Highways Technical Note – Response to Highways Comments from North Yorkshire County Council

Outline application for up to 5 no. Dwellings – Land West of Highfield, Sled Gates, Flyingthorpe

Planning Application Reference (North Yorkshire County Council) – NYM21/0351/OU

23rd July 2021

Figure 1 - Eastern ATC Street View Location:

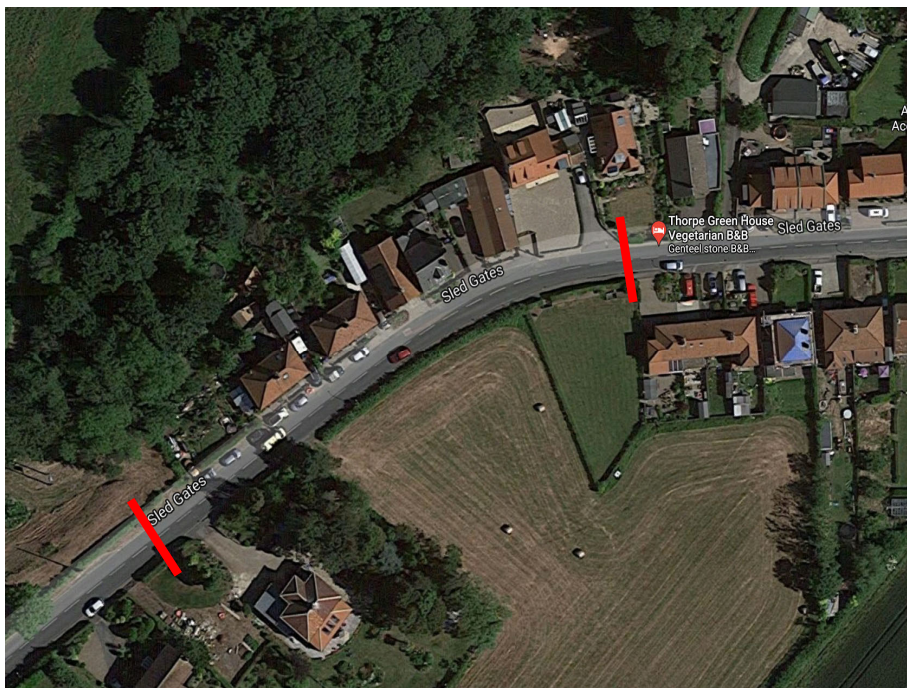
The details refer to the fact that two surveys were carried out but the locations have not been mentioned. Can these locations be confirmed and ideally shown how close they are to the 57 metres south west of the proposed junction and 40 metres north east.

Both ATCs were located along Sled Gates at the extremities of the proposed visibility splays. Details of the locations for both the eastern and western ATC points are provided in *Figure 1*.

Drawing No. **AMA/20940/SK005** Rev. **-**

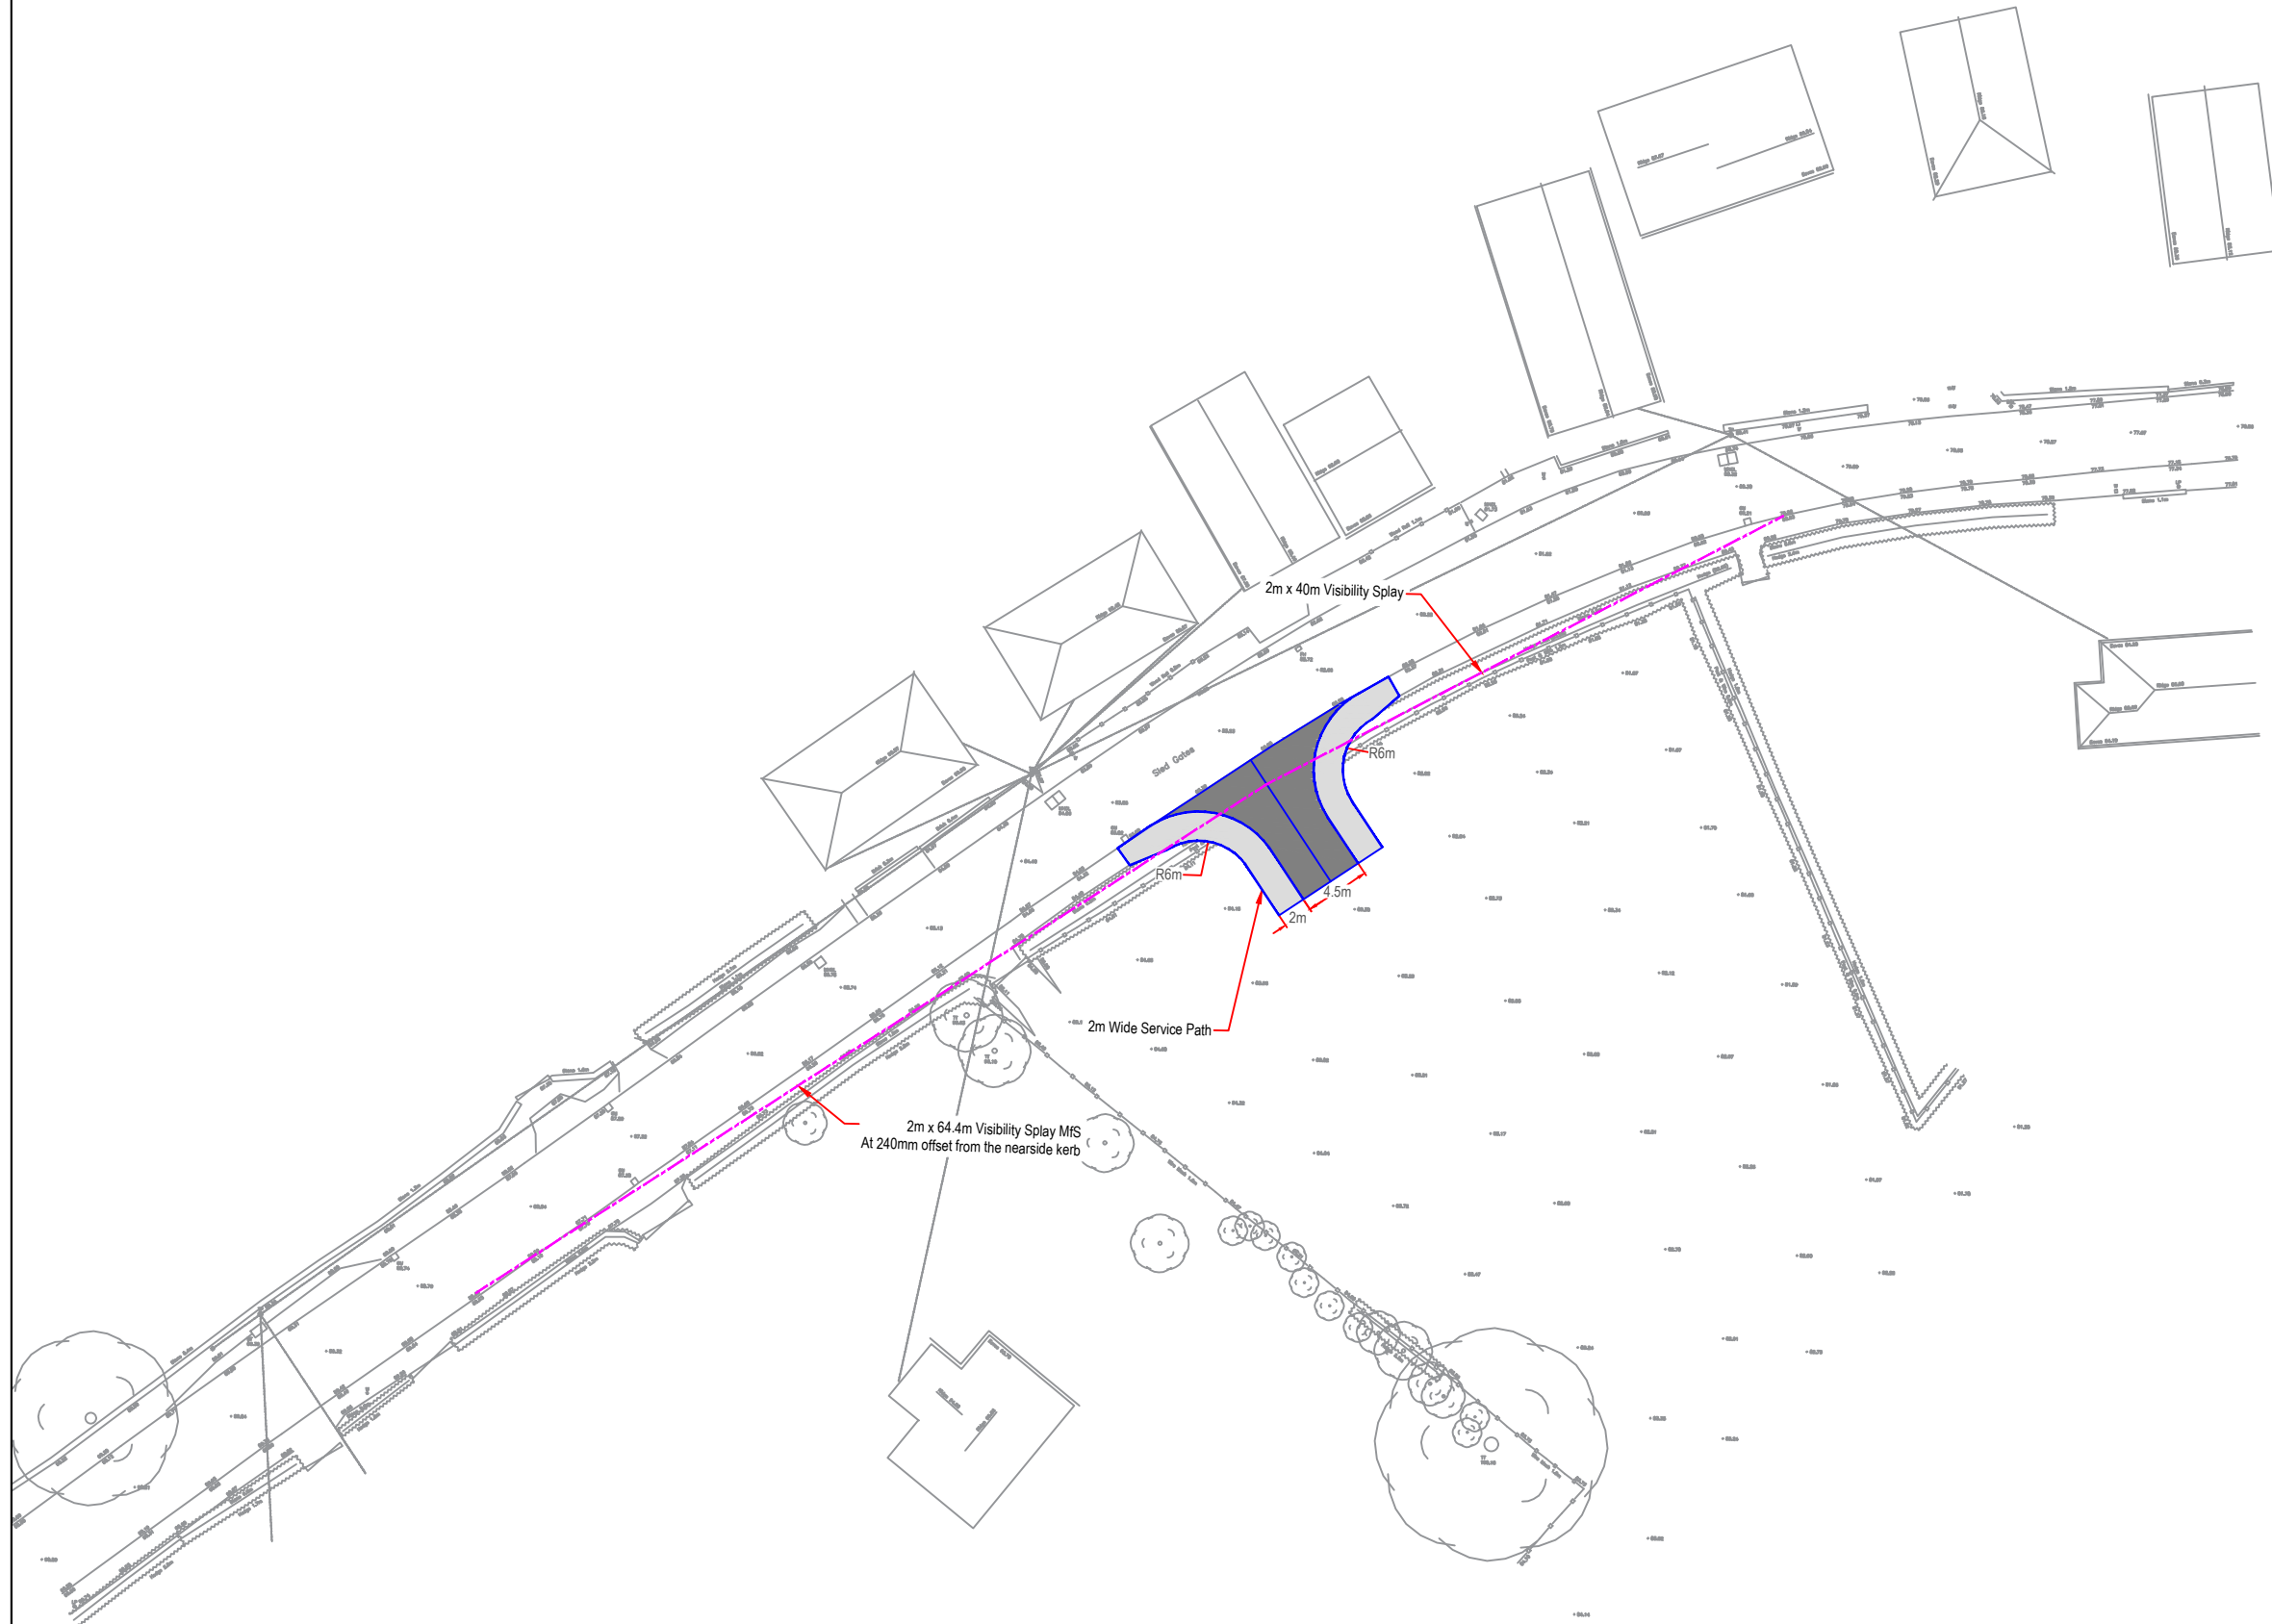
For the vision splays to be achievable, it is relying on neither of the two neighbouring plots to have any hedges or vegetation growing over the highway boundary. Traditionally, the local Highway Authority would only write to the owners of the properties with any over hanging vegetation concerns following a routine inspection or an inspection following a complaint.

No consideration to the incline of the road appears to have been taken into consideration. Have the gradients at the points surveyed being measured.

As the road is a bus route, an allowance for a safe stopping distance of these vehicles should be applied.

As per NYCC policy, given the site is for less than six dwellings and is a private drive a 2m setback is NYCC policy compliant. This is reflected in an updated visibility splays plan, SK-005, in **Appendix B** of this document. Further detail is provided in later AMA comments.

We have appended an updated visibility splays plan (SK-005) to this note based on a 64.4m SSD for the western visibility splay. This splay is offset from the nearside kerb by 240mm into the carriageway.

It is generally accepted that this is acceptable to a maximum of 600m from the nearside kerb as this would be the width of a cyclist, which is a minimum 'vehicle' width.

It should be noted that this splay is not into oncoming vehicular traffic and is the offside lane, therefore vehicles would be highly unlikely to be oncoming towards the junction and on rare occasions overtaking vehicles, which is not considered likely given the residential 30mph area.

As detailed in the submitted Highways Supporting Statement, the average speed in this instance was 31.3mph and buses travelling at 90% would be 28.2mph. As such the SSD calculations provided in Comment 6 and shown on the updated SK-005 appended are more than sufficient to cater for bus stopping distances and are considered acceptable.
